SAFETY EVALUATION BY THE OFFICE OF NEW REACTORS LICENSING

TOPICAL REPORT (TR) 1015-18653-P (REVISION 1) “DESIGN
OF HIGHLY INTEGRATED PROTECTION SYSTEM PLATFORM”

NUSCALE POWER, LLC

DOCKET: PROJ0769

Figure 3-4 Typical plant signal data flow path in HIPS platform

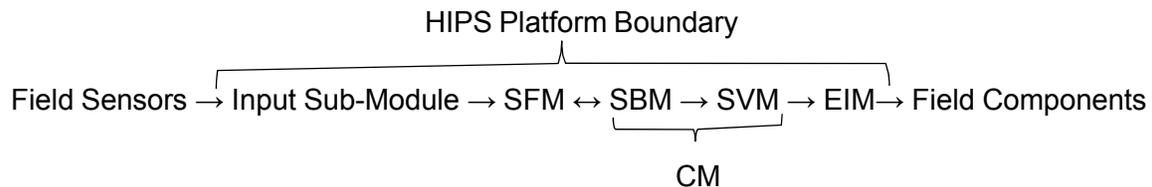
Figure 3-4 shows a typical plant signal data flow path in the HIPS platform:
